SAFETY RECALL CODE 0820 - SHOCK REINFORCEMENT PACKAGE (SRP)

00V-163

July 26, 2000

Figure 1. Front Reinforcing Collar and Metal Strap)

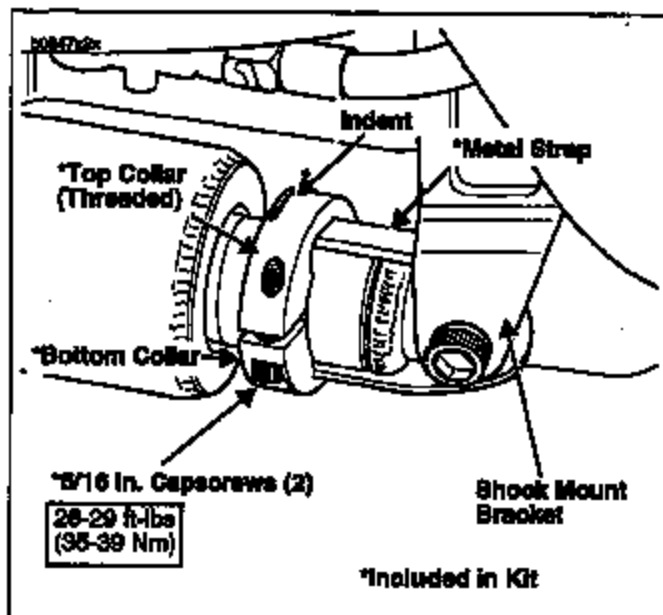
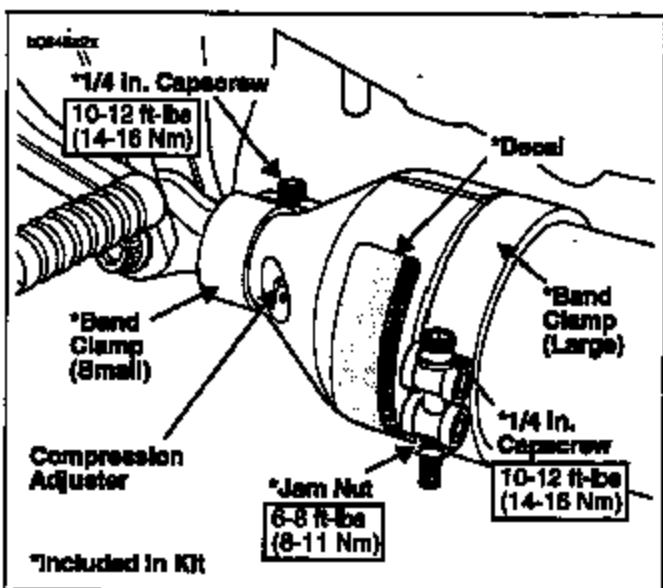
2. Disconnect negative battery cable.
3. Make sure shock absorber is clean and free of oil and grit.
4. X1 Models Only: Remove chin fairing. See Section 2 of Service Manual for procedure.
5. See Figure 1. Slide metal strap through shock mount bracket and over front shock eye.

6. See Figure 1. Position front reinforcing collar halves (threaded piece on top with indent oriented rearward) on front of shock, over metal strap.
7. Install two socket head capcrews from bottom. Pull collar rearward to take up slack and press metal strap flush against shock eye. Make sure metal strap is centered on indent on collar. Evenly tighten screws to 26-29 ft-lbs (35-39 Nm).
8. See Figure 2. Position rear reinforcing collar halves on left and right sides of rear shock. Make sure compression adjusting dial is aligned with and visible through opening on collar.
9. Position small band clamp on rear of reinforcing collar with mounting hardware holes on inboard side.
10. Insert socket head capcrew and washer from the top and install washer and jam nut on the bottom. Tighten capcrew until snug.

Figure 2. Rear Reinforcing Collar

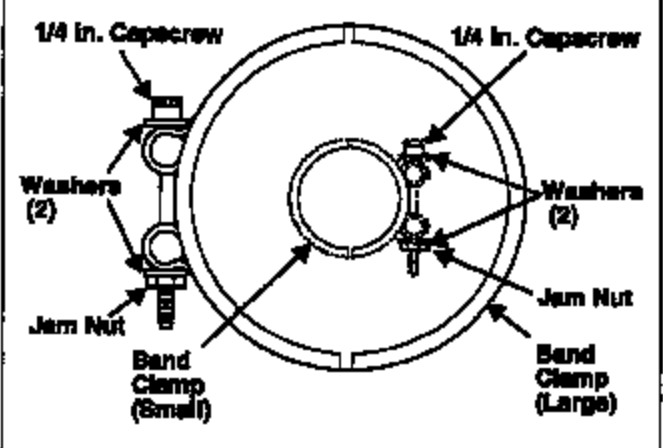
Make sure to position the large band clamp on front of reinforcing collar with mounting hardware on outboard side. Any deviation from this position could lead to inadequate clearance with the oil lines, the ground or the muffler during suspension travel. Band clamp hardware interference with oil lines, muffler or ground could result in an accident and death or serious injury.

11. Position large band clamp on front portion of rear reinforcing collar with mounting hardware holes on outboard side.
12. Insert socket head capcrew and washer from the top and install washer and jam nut on the bottom. Tighten until snug.

16. See Figure 2. Position warning decal on rear reinforcing collar behind large band clamp.
17. X1 Models Only: Install chin fairing. See Section 2 of Service Manual for procedure.
